Determination 2010/75

Refusal to issue a code compliance certificate for a 12-year-old addition to house at 11 Duders Avenue, North Shore City

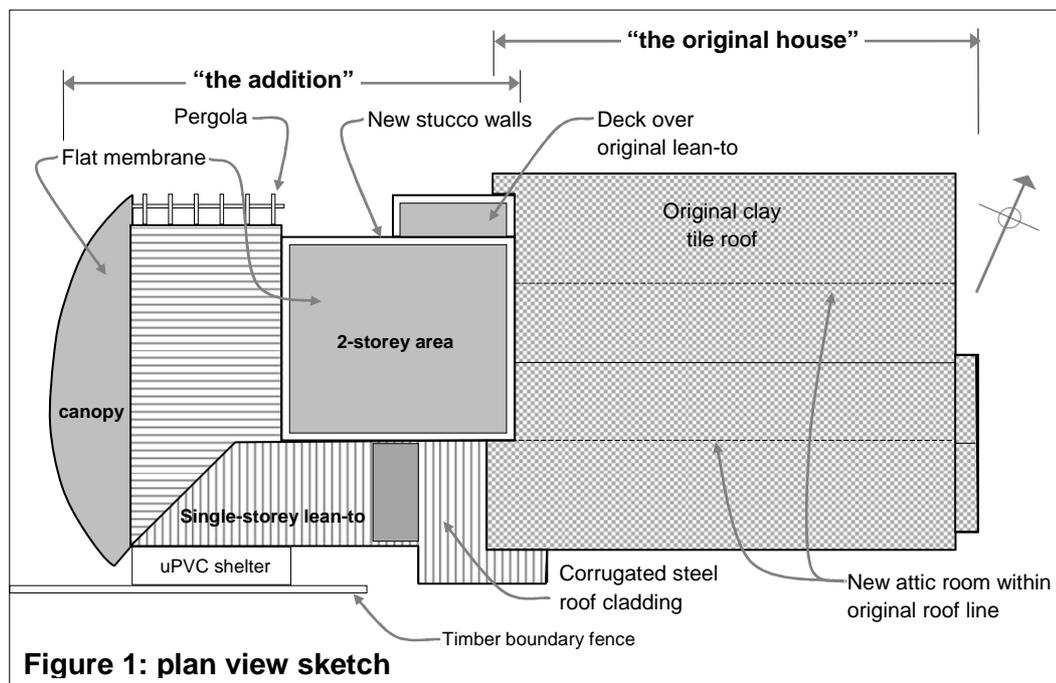
- 2.3 The addition is to the rear of the house as shown in Figure 1, and provides:
- a new kitchen, dining and family area on the ground floor
 - two small bedrooms and a bathroom in the upper level, with a developed attic area under the original roof and a new window to the east gable end wall

- a new upper level deck from an upper level bedroom, above the walls of the original lean-to to the house.
- 2.4 Construction of the addition is generally conventional light timber frame, with a concrete slab and foundations, monolithic and timber weatherboard wall claddings, membrane and profiled metal roof claddings, and timber windows to match the original windows. The altered house is fairly complex in plan and form, with three different roof claddings at varying pitches and levels, and the upper level roof bordered by parapets.
